Rezoning Transportation Analysis
Petition Number: Insert Zoning Petition #2021-226
General Location Identifier: 02902129, 02902130

Revision Log:

Date	Description
02-24-22	First Review (PDM)
03-24-22	Second Review (PDM)
04-27-22	Third Review (PDM)

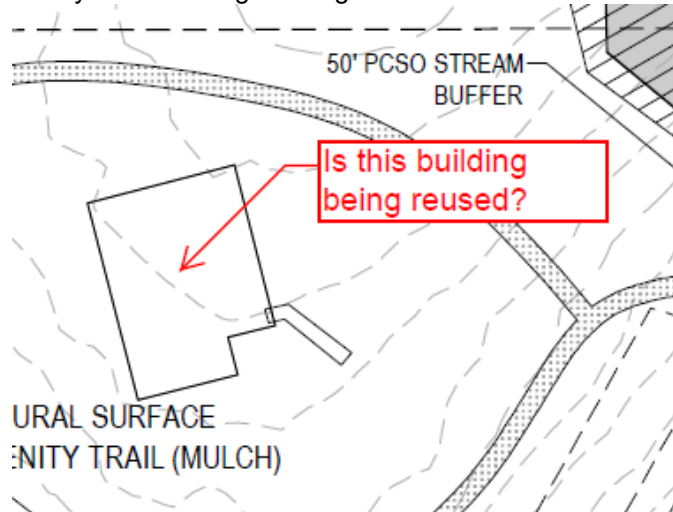
~~2. **Revise site plan and conditional note(s) to commit to dedicate 30 feet of right-of-way from the road centerline of Galloway Road. The site plan shall label and dimension the right of way from the road centerline. Callout the proposed right of way line as "Proposed ROW."**~~

~~**Outstanding Comment from 02.24.2022:** Add centerline of roadway to Galloway Road and callout the proposed right of way line as "Proposed ROW".~~

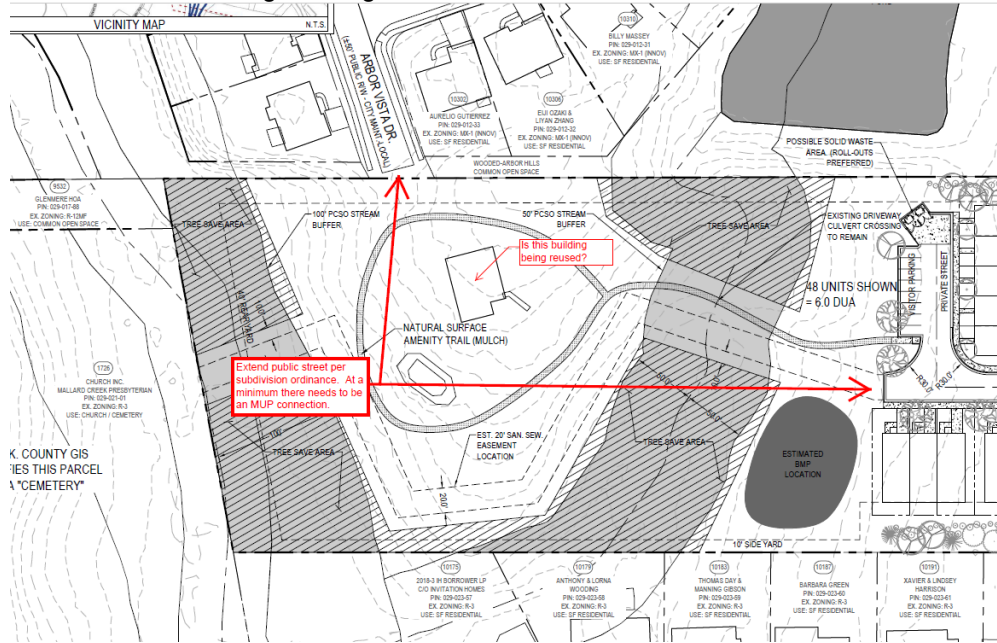
~~3. **Outstanding Comment from 02.24.2022:** Revise site plan to show the proposed 8-foot sidewalk and 8-foot planting strip located along Galloway Road per the conditional note 4.B.~~

~~b. The petitioner will construct an eight (8) foot planting strip and an eight (8) foot sidewalk along Galloway Road as generally depicted on the Rezoning plan.~~

~~4. **Revise the site plan to clarify if the existing building onsite will be removed or reused.**~~

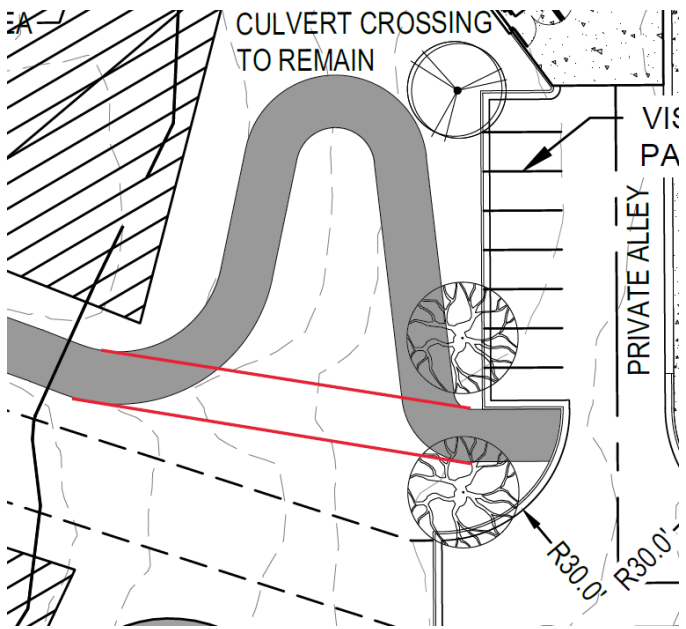
5. ~~Revise site plan and conditional note(s) to commit to construct a 12-foot multi-use path that connects the Arbor Vista Drive stub street to the proposed street per Chapter 20. Provide a public access easement for the multi-use path route. CDOT may request the existing Arbor Vista Drive be extended with a public road if the existing building will be removed.~~

Outstanding Comment from 02.24.2022: Provide a public access easement for the multi-use path route. In addition, CDOT recommends stairway/path connecting MUP.

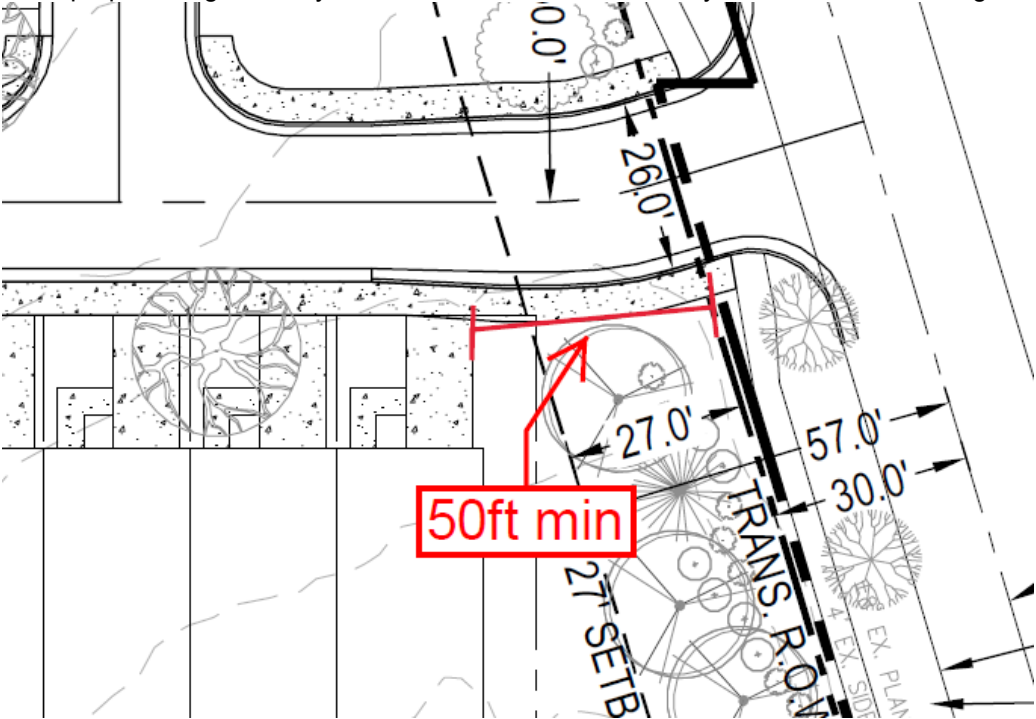
6. ~~Outstanding Comment from 02.24.2022:~~ Revise site plan to provide a minimum 50-foot stem between the proposed right of way and the first residential driveway. Dimension stem length.

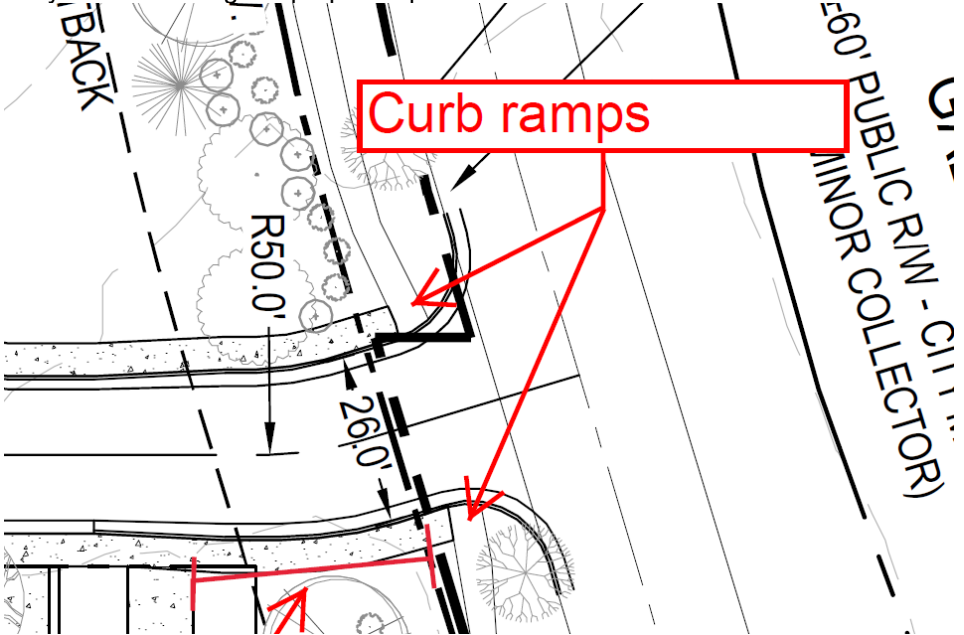
7. ~~Outstanding Comment from 02.24.2022:~~ Revise site plan to provide curb ramps for the sidewalk along Galloway Road crossing the proposed private street.

8. Revise site plan to show the entire section of Galloway Road existing curb and gutter along the property frontage. Label and dimension the curb and gutter front the centerline of the road.

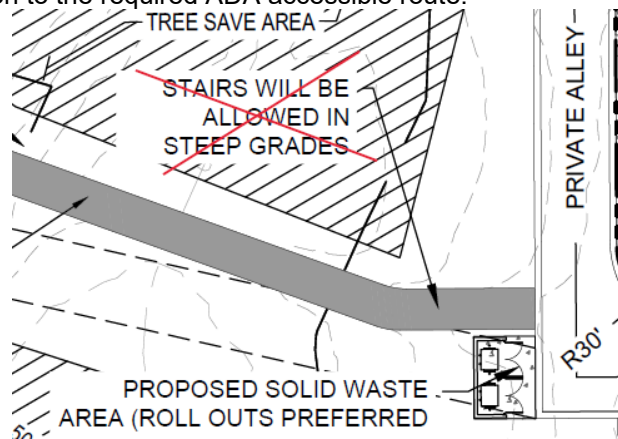
10. **New Comment from 04.27.2022:** Revise site plan to remove note regarding stairs allowed for steep grades. The required multi-use path must be accessible, and the request to add stairs between the jogged path was in addition to the required ADA accessible route.
